URGENT MEDICAL DEVICE CORRECTION

GEHC Ref# 36127A

RE: CARESCAPE B450, B650, and B850 (Bx50) monitors may restart due to network overload situation caused by network misconfiguration

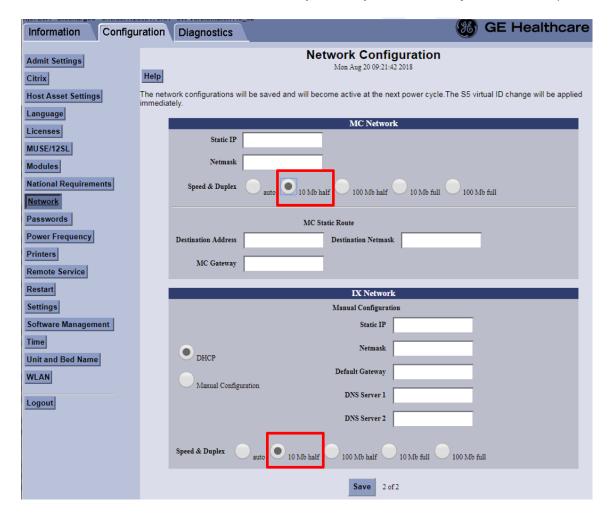
- 3. Select Next to proceed on Network Configuration.
- 4. In the MC Network and IX Network tables select Speed & Duplex to 10 Mb Half as shown in the picture below.

- 5. Select Save.
- 6. Restart the monitor and wait until it starts up. The new configuration become active once monitor is restarted.
